**ADDENDUM #5**

**Will County Health Department**  
**BID PACKAGE #2 – Misc. Steel/Structural/Enclosure**  
**November 15, 2018**

**SECTION 00 91 07  
BP #2 - ADDENDUM NUMBER 5**

**PROJECT:**           **WILL COUNTY HEALTH DEPARTMENT - NEW HEALTH DEPARTMENT  
BUILDING  
501 ELLA AVENUE  
JOLIET, ILLINOIS 60433**

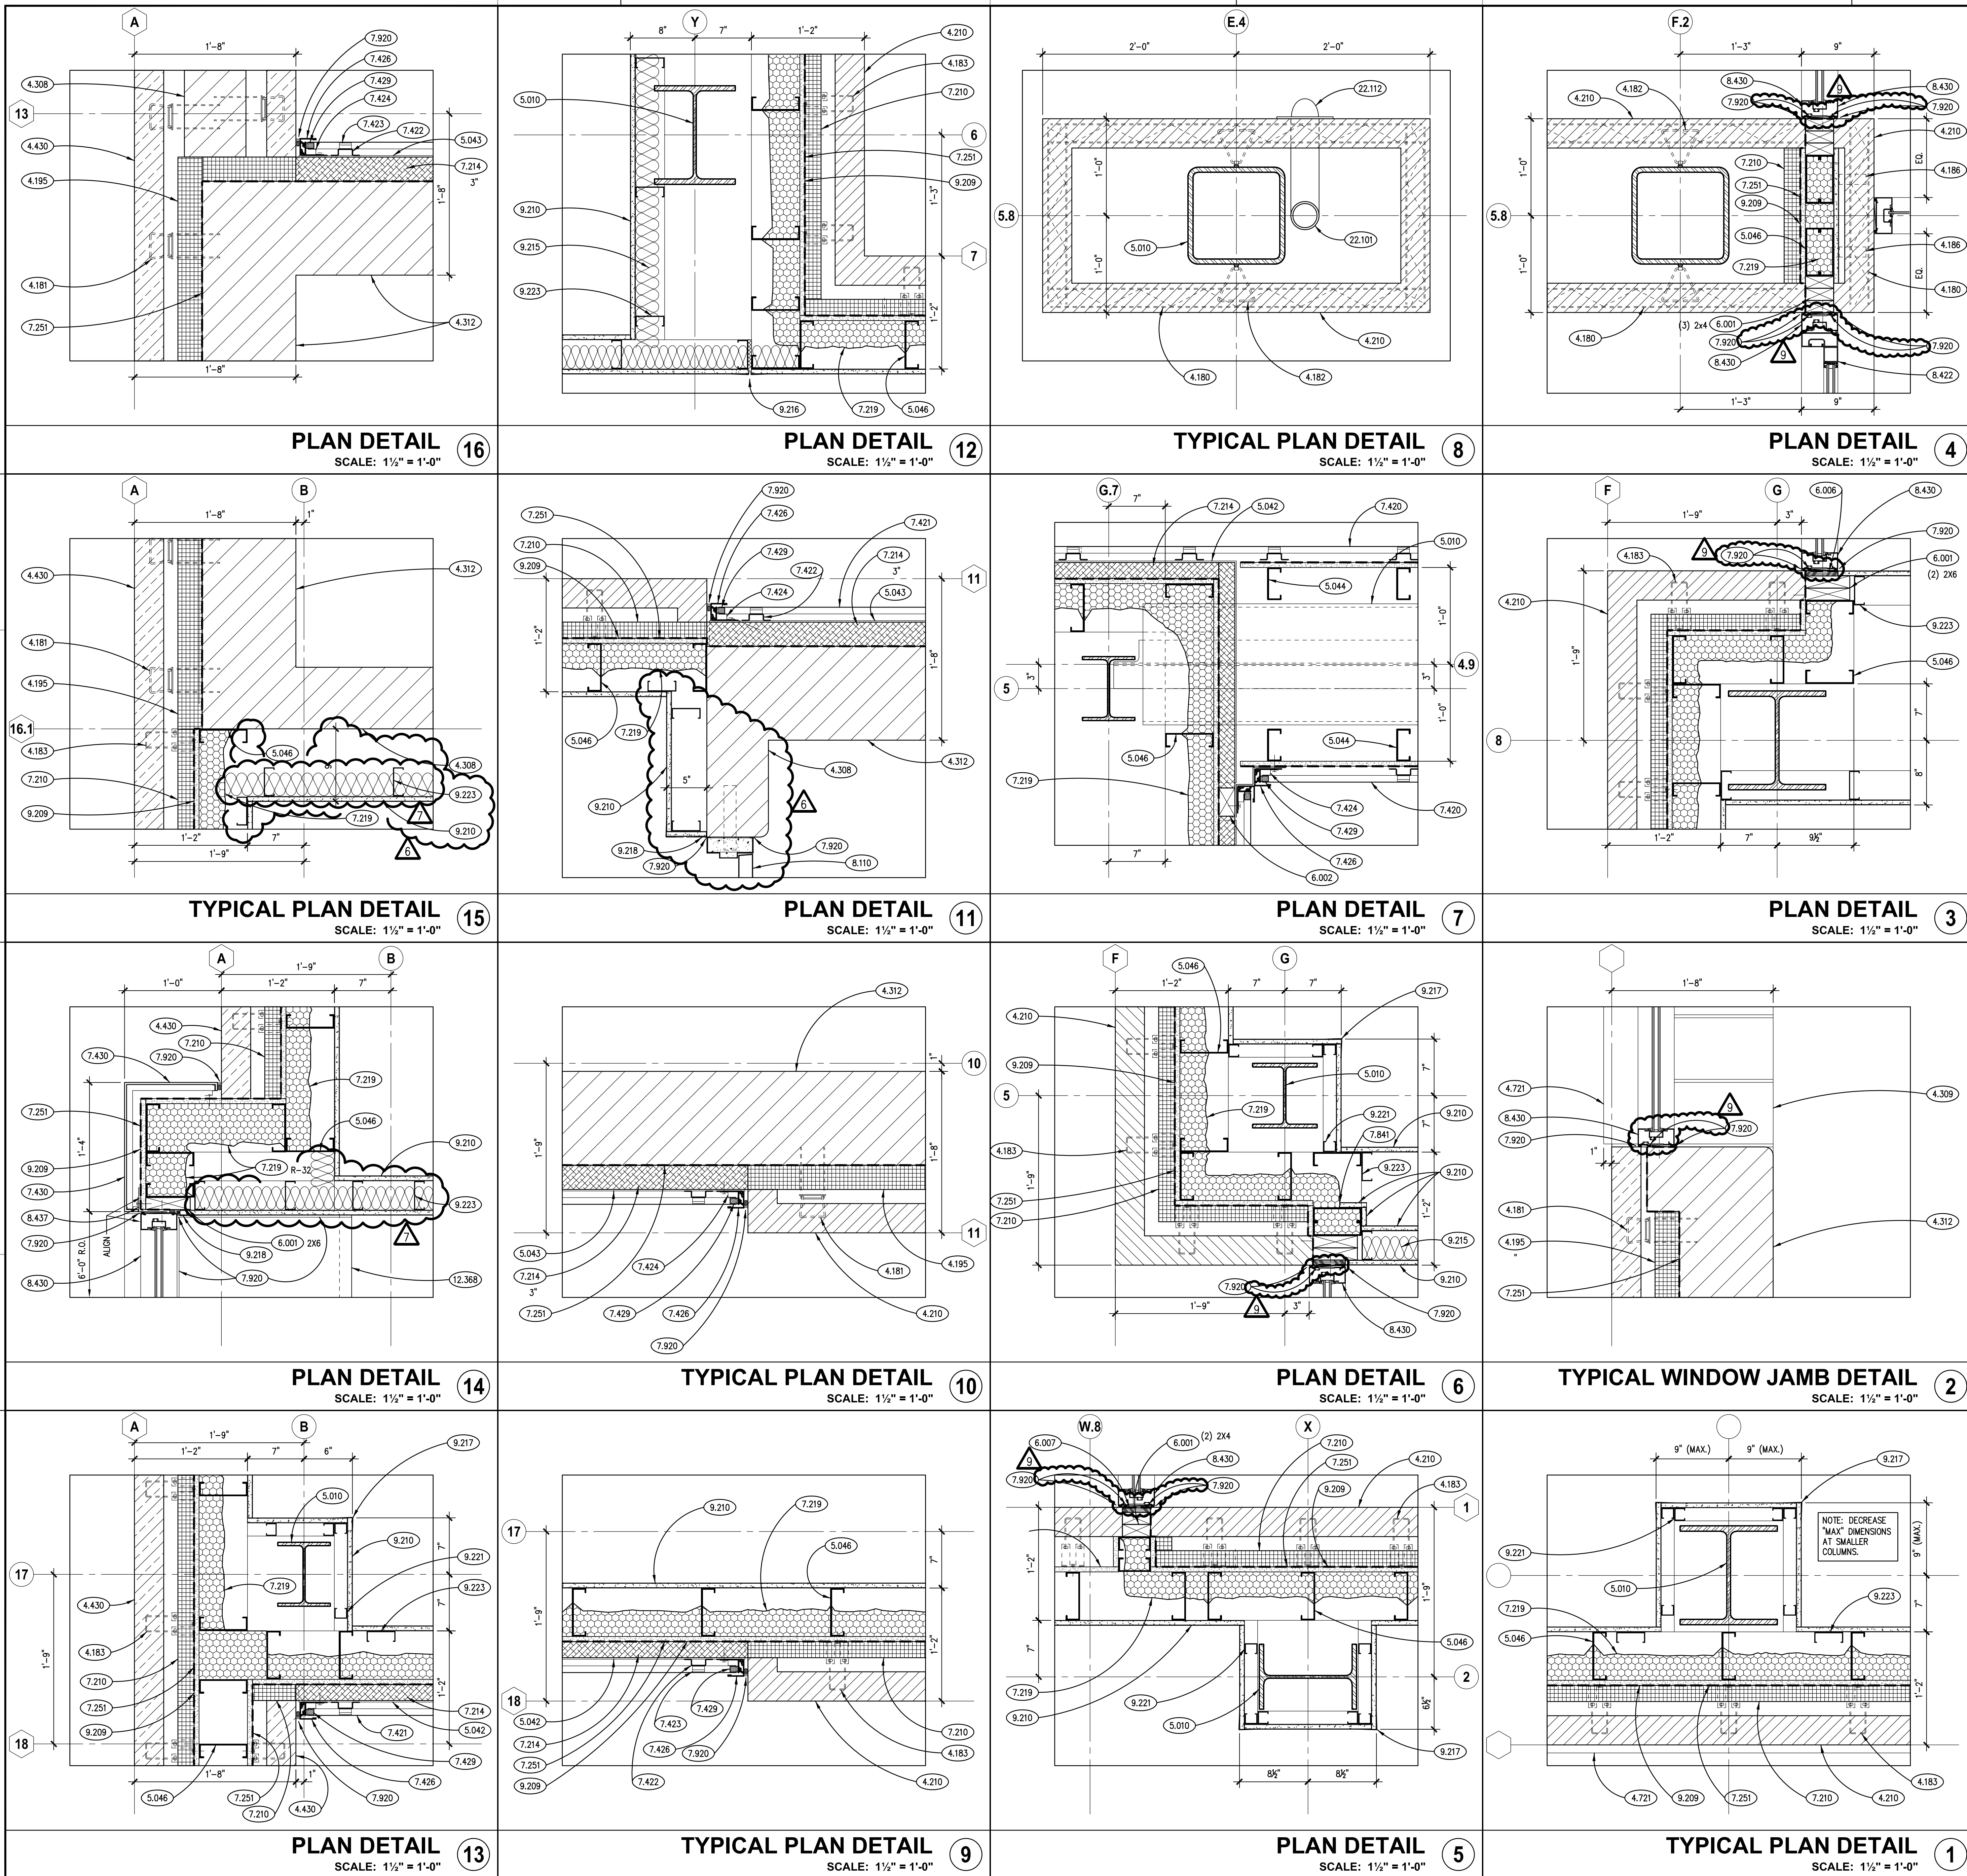
- A. Revisions to the weather barrier coating placement and termination points. Minor modifications to the details as noted. Refer to revision cloud 9 for specific changes.
- B. Added General Note #4.

- A. Revisions to the weather barrier coating placement and termination points. Minor modifications to the details as noted. Refer to revision cloud 9 for specific changes.
- B. Added General Note #4.
